RE: Wayne Glen (formerly Richter Tract)
Conditional Use Stormwater Management Review
Stormwater Management Review Letter No. 1

**Re: Wayne Glen Independent Stormwater Review
Tredyffrin Township, Chester County, Pennsylvania
pH No. 1380.001**

Figure 1. Screen shot of Overall Stormwater Plan showing reliance on Permeable Pavers.

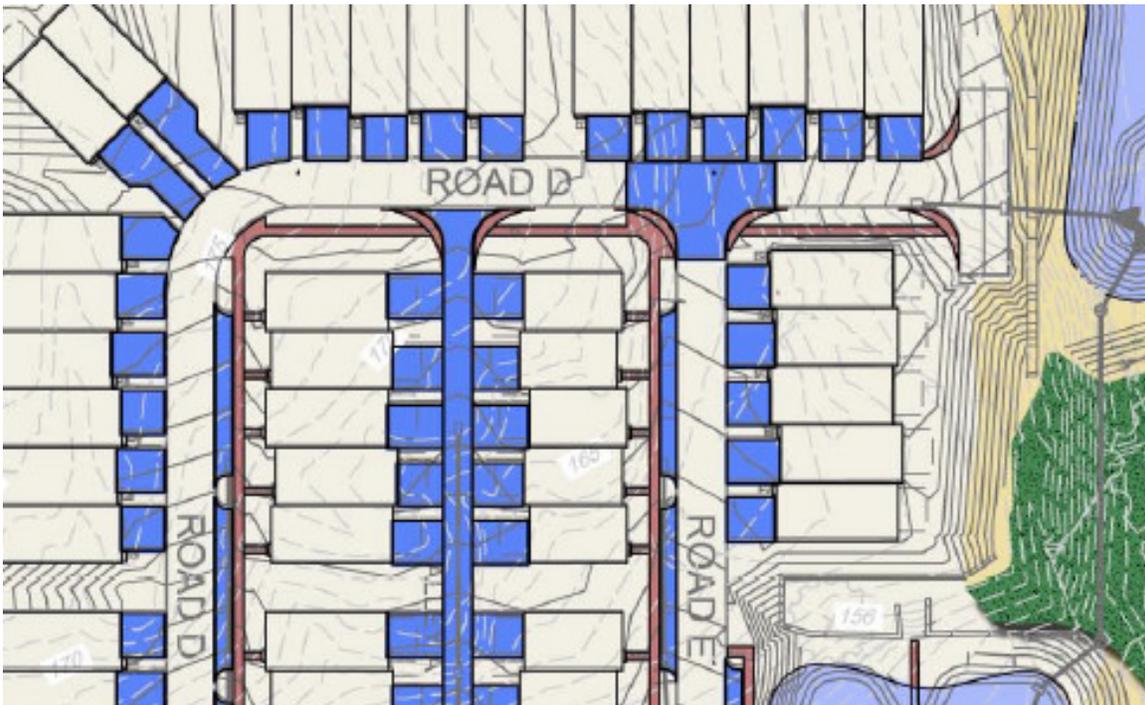
The application proposes the widespread use of Permeable Pavers in an effort to comply with the volume control requirements. A total of over 88,000 square feet of Permeable Pavers are proposed. This SCM is an ideal tool which is frequently used to distribute infiltration across a site and manage rainfall/runoff close to its source. The incorporation of the Permeable Pavers on the proposed residential parcel is commendable and will undoubtedly have positive impacts on the stormwater management of the proposed development. An example screen shot from the Overall Stormwater Plan is provided below in Figure 1 to illustrate the density and amount of Permeable Pavers used in the design. The Permeable Paver areas are shown in dark blue.

Since the application relies heavily on Permeable Pavers, the method used to account for the volume control capabilities should be as accurate as possible. However, in our

independent assessment of the anticipated two-year storage volume provided by the Permeable Pavers, we determined that the storage is likely over estimated by over a factor more than three (3); or 310%. To understand this discrepancy it is necessary to explain how Pennoni accounted for storage in the Permeable Pavers and how we suggest it should be accounted.

The Permeable Pavers are proposed to be constructed over a crushed stone storage bed. The thickness of the bed is typically two (2) feet for the majority of the area but is over six (6) feet in some areas in order to extend down to existing grade. The volume/storage calculations for these SCMs account for the entire storage in the bed. As discussed previously, it is our opinion that storage in excess of the two-year runoff volume should not be counted towards compliance with the requirement. Furthermore, most of the Permeable Paver areas have little to no contributory drainage area; that is to say that they only manage rainfall that fall directly on them. For a stone storage bed of 40% void space (standard but likely high) the entire volume of the two-year storm (3.21 inches) would be contained in a stone bed depth that was approximately eight (8) inches thick. Therefore any storage in excess of this thickness should not be counted towards compliance with the two-year volume control requirement. Review of the proposed total area and storage of the Permeable Pavers indicates that the average thickness is 2.1 feet, which is roughly a factor of three times larger than what should more accurately be counted.

Additionally the proposed Permeable Paver areas are generally not level. Notable areas include the driveways for all residential units and Alley A between the proposed Townhomes. Alley A varies in elevation by approximately 14 feet from the north end to the south end. The stone storage bed beneath the Permeable Pavers is only proposed to be one (1) foot thick. The storage calculations assume the bed will provide an even depth of storage throughout the entire length and 14 foot vertical elevation differential. In reality rainfall that infiltrates the upgradient pavers will flow up and out of the pavers at the lower end of the alley. Based on the proposed slope of the alley, only approximately the bottommost 50 feet of the 600 foot long alley will likely provide appreciable storage. An analogy for this concept is a cookie sheet tray. It can store the full volume of water when flat, but a slight slope will eliminate most of its storage.

For this reason Appendix B of the Township Ordinance (Section 2. Design Considerations b.) states that “infiltration BMP bottom areas shall be level and in no case shall have a slope greater than 0.5%.” The slope in the proposed ally is greater than 2%. Our estimates for the Permeable Paver storage do not account for lost storage due to slope.
